STAFF REPORT FOR THE HISTORIC REVIEW BOARD

FILE NUMBER: DR-14-02

REQUEST: Designation removal, rear porch addition, window replacement, garage replacement

PREPARED BY: Sara Javoronok, Associate Planner

Photographs of original and replacement windows side by side. Note that the windows are in different positions on the house so the comparison is limited.

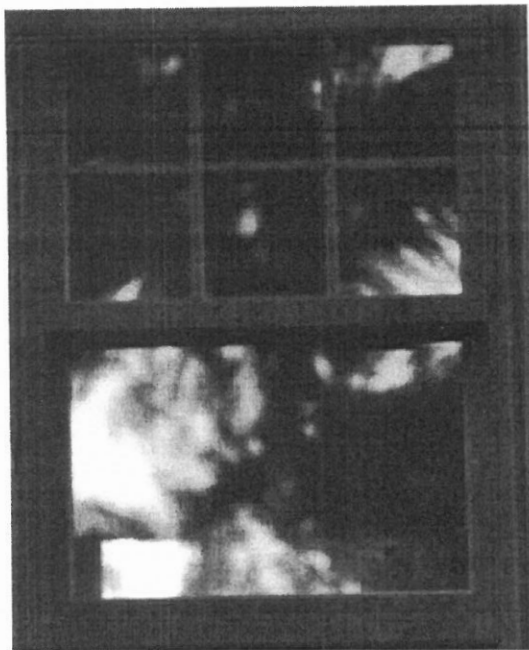
One can see that it is nearly impossible to tell the two apart as their dimensions are as similar as one can make. It also does not detract from the "historic" nature of these "not in period of significance" windows.

October 2013 – Front and side (north) elevation

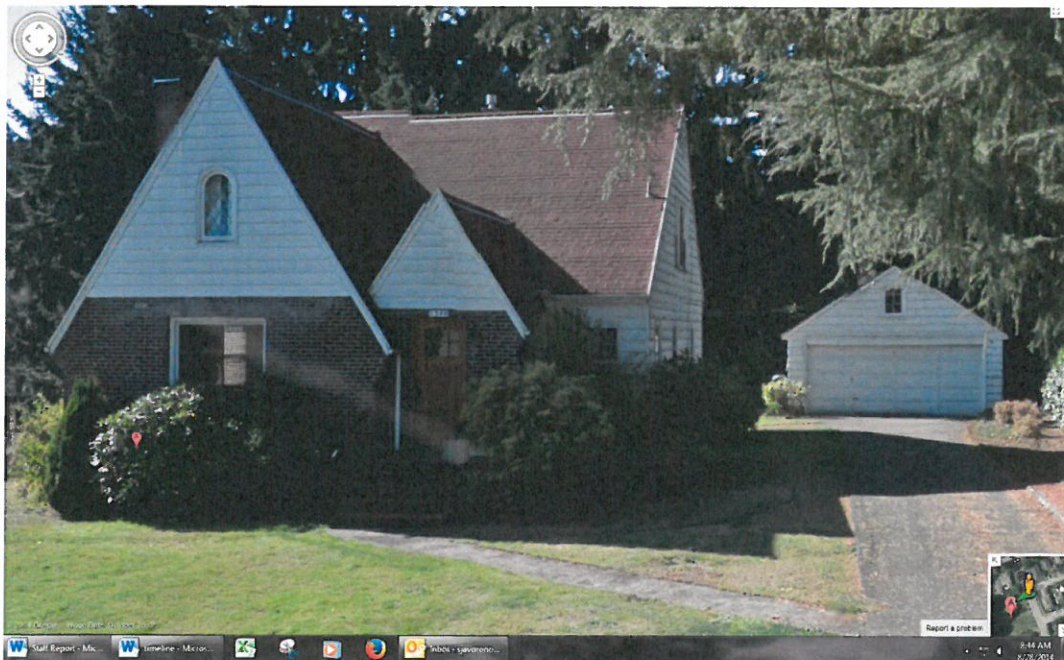
At that point, staff encouraged the property owner to change the planned construction of the dormer so that it was not flush with the north elevation as seen below:
